Council assessment of Clause 4.6 request

1 Overview

The applicant has lodged a Clause 4.6 variation request to vary the height control of State Environmental Planning Policy (Precincts - Central River City) 2021. A copy of the applicant's Clause 4.6 submission is at attachment 8.

2 Visual representation of offset

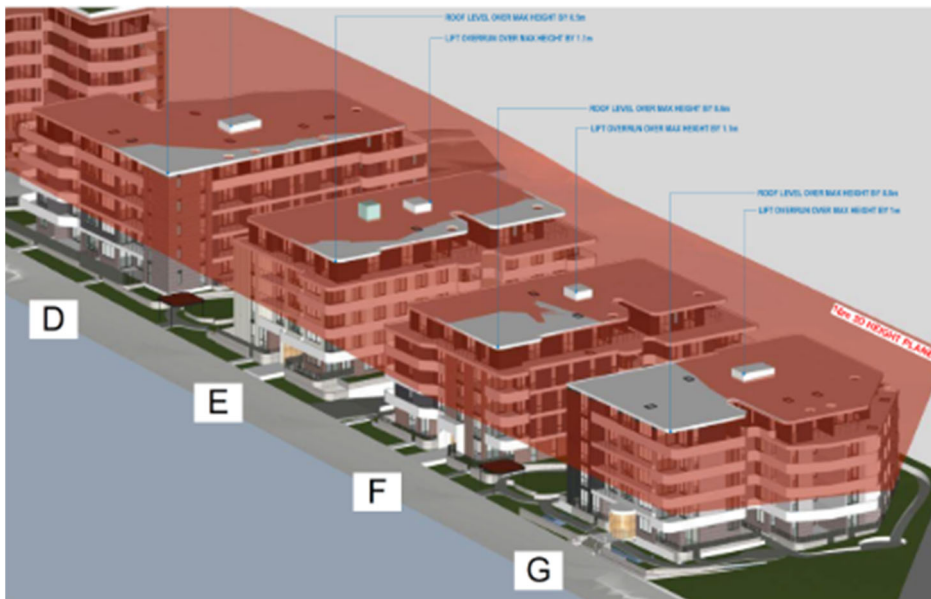
The proposed structures coloured in grey (above the red blanket) in the image below exceed the 16 m maximum building height permitted under the State Environmental Planning Policy (Precincts - Central River City) 2021.

The proposed lift overrun to the rooftop communal open space on Building C exceeds the height by up to 4.7 m. Point encroachments to top of the lift overruns is also proposed on the other buildings ranging in height of between 1 m and 1.3 m (6% - 8.1% variation). Other height variations are also proposed between 0.5 m and 1.5 m (3.1% - 9.4% variation) to ceiling areas of habitable floor spaces and roof parapets, as follows:

Consequently, the proposed building height is 4.7 m at the highest point to the lift overrun to Building C. This is a variation of 29.4%.
